Re: Response to August 1, 2001 Comment letter from Jennifer Shoemaker, "Review of Report of Phase IA Activities Corrective Measures Study"

Solutia Inc. Facility; 1 Monsanto Road, Nitro, West Virginia ("Site")
EPA ID. No. WVD039 990 965

Responses to USEPA Comments in August 1, 2002 letter: "REVIEW OF REPORT OF PHASE IA ACTIVITIES – CORRECTIVE MEASURES STUDY"

Dwg. No.
FIGURE 1

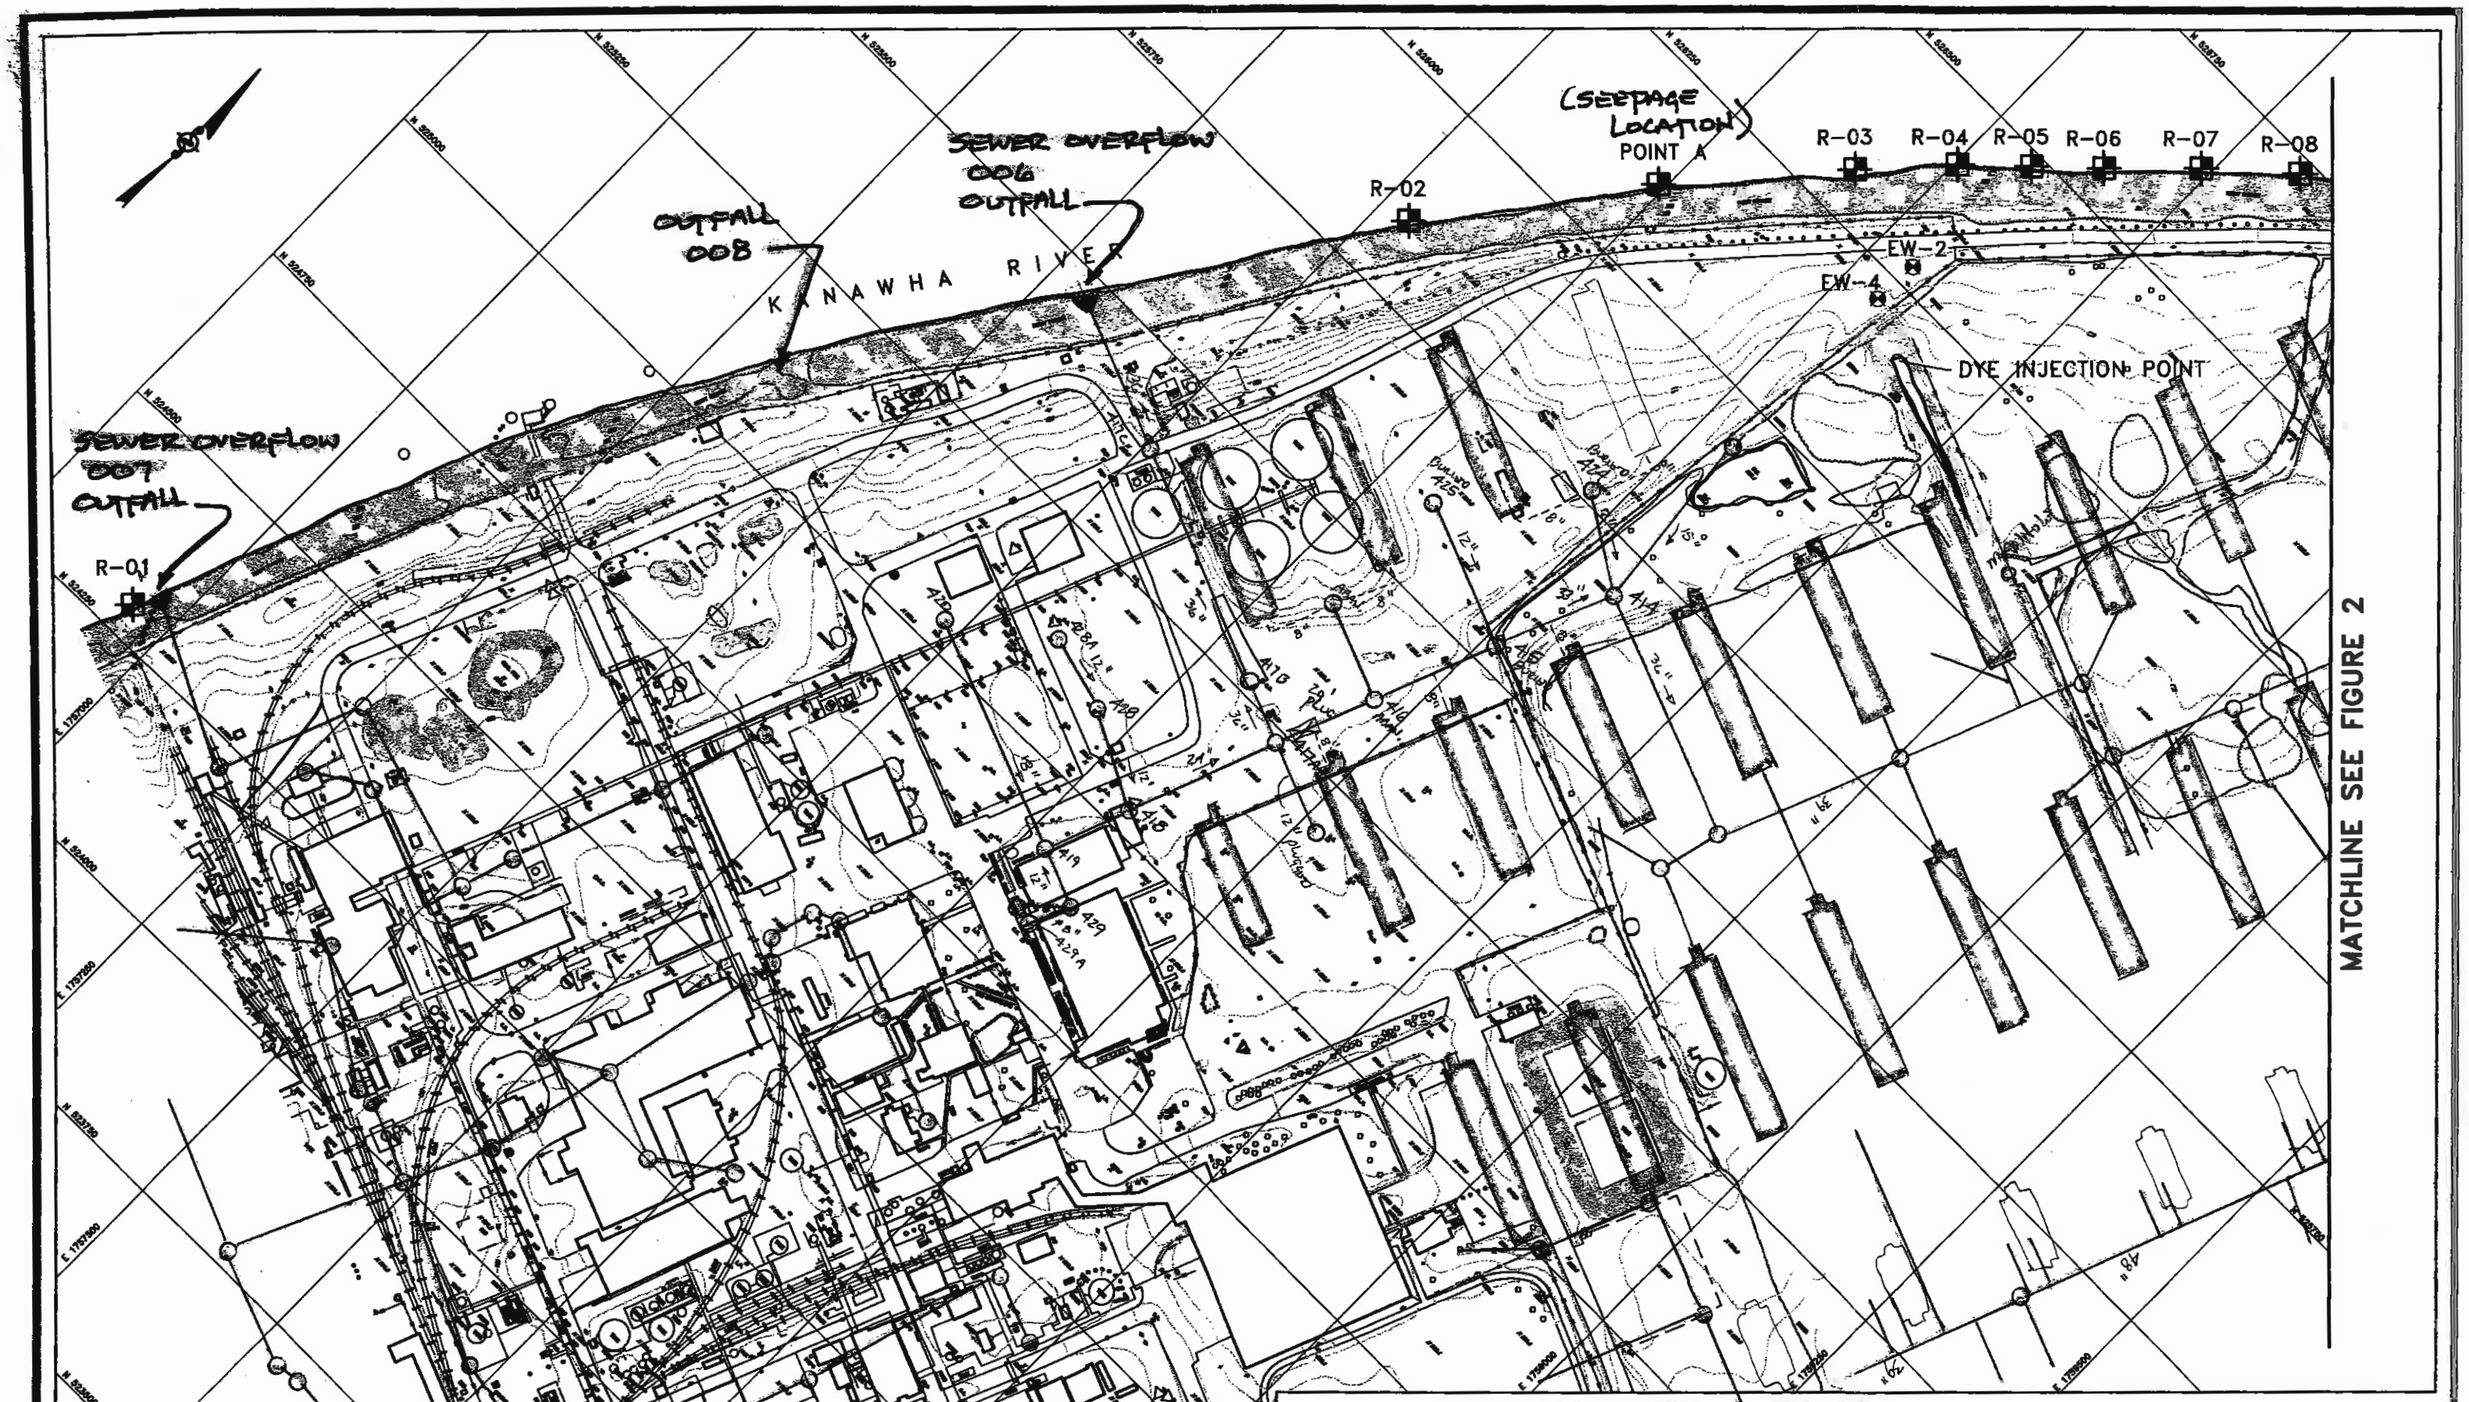
2. Dye Study – Solutia must provide information on the dye study that was conducted at the facility in response to West Virginia Department of Environmental Protection (WVDEP) Water Program. This should include a map showing the dye injection location, the groundwater seep location, procedures followed during the event and evaluation of the results of the study.

Response: ***The referenced dye study was conducted by Potesta & Associates, Inc. in January 2001 to determine the relationship between impounded water in the adjacent, off-site HUB Industrial Park drainage ditch and the increase in runoff from the 3 acres soil cap on the AES site. The cap was constructed under a Remedial Action Plan (RAP), which was reviewed and approved by Mr. Dennis Matlock of the USEPA. The dye study was voluntarily completed during the design phases of the AES capping project.***

A map showing the location of the seep and the dye test sample points has been prepared. Also, a narrative of dye study detaining the tests and findings of the study are also included – both in Attachment II.

The dye study incorporated ten receptor locations, which were established along the Kanawha River. These locations were denoted as sampling points R01 thru R10 and are indicated on the attached figures 1 and 2. Two additional receptors were suspended in existing extraction wells located in the adjacent LNAPL area. These were added to determine if flow from the ditch line was recharging the LNAPL area. A one-time receptor was placed and retrieved from a manhole (no. 414) in the old City of Nitro sewer near the end of the study location. The receptors were individually prepared using 12 grams of fresh activated coconut charcoal contained in a 3-inch by 5-inch nylon mesh packet. The river sample points were established by driving a 2-foot piece of rebar into the river sediment at the edge of the water at each location. The receptor packet was then attached to the rebar for anchorage with a plastic zip tie. The receptors that located in the extraction wells and manhole were suspended from the ground surface from a nylon cord with zip ties. Each of the receptors was weighted to ensure full submergence.
